ADVANCED NUCLEAR FUELS CORPORATION

DOCUMENT TITLE: ADVANCED NUCLEAR FUELS CORPORATION
QUALITY ASSURANCE MANUAL

Subject: PART II OF ANF-1, REV. 70

SUBJECT: ACCEPTANCE OF REVISION 23 TO ADVANCED NUCLEAR FUELS CORPORATION
(ANF) QA TOPICAL REPORT

FIGURE 1

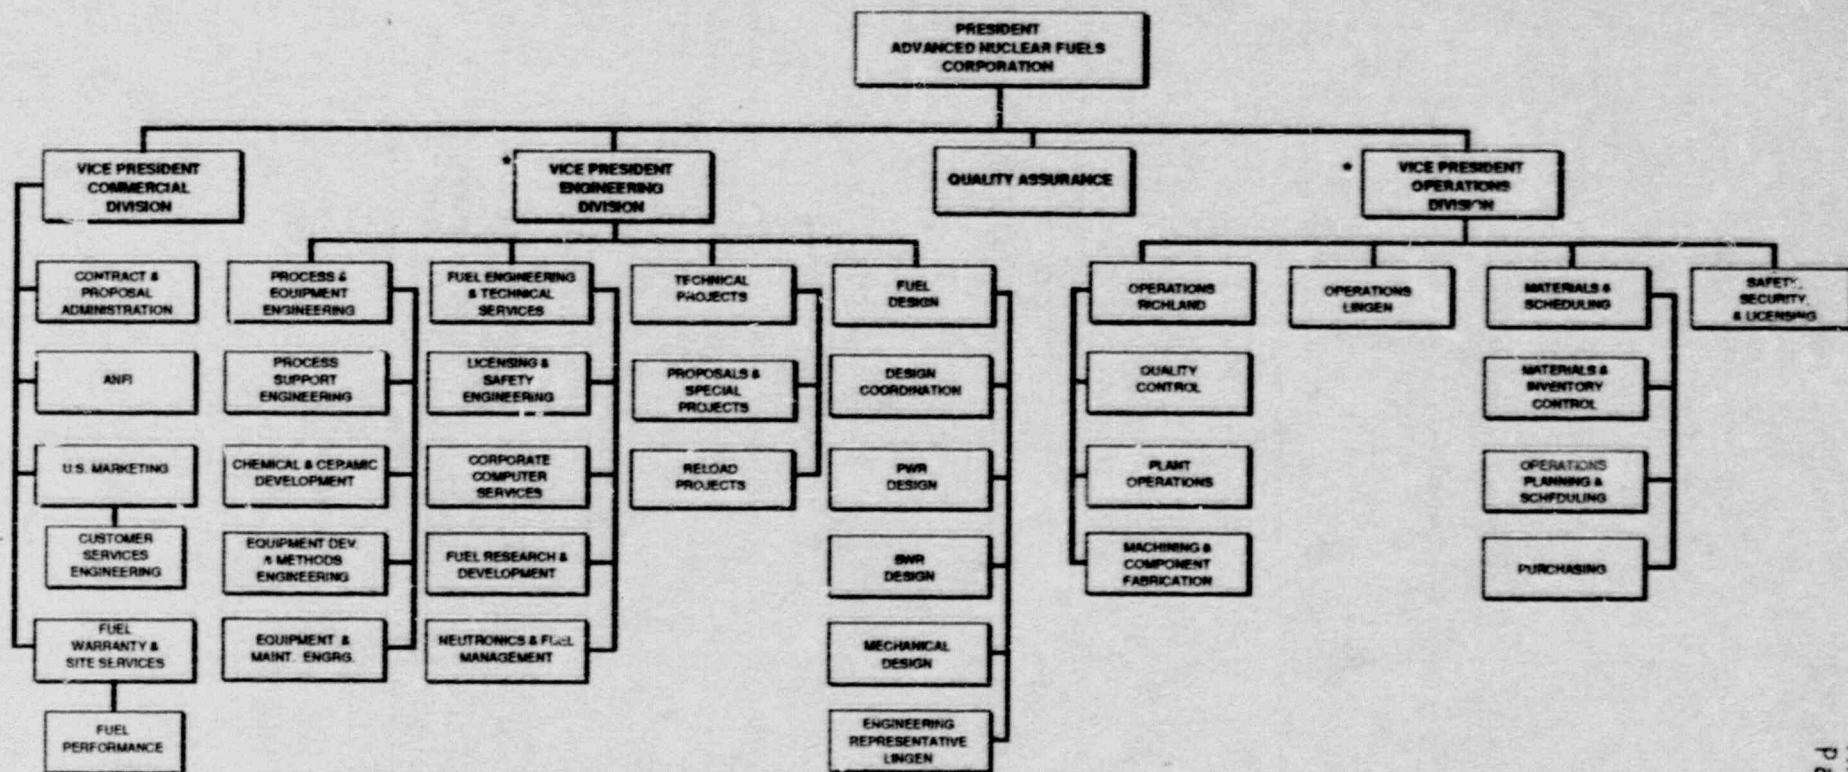
12. Figures 1 and 2 were revised to show current organization.
13. Various formatting changes (indenting, paragraph titles in Section 1) were made for consistency.
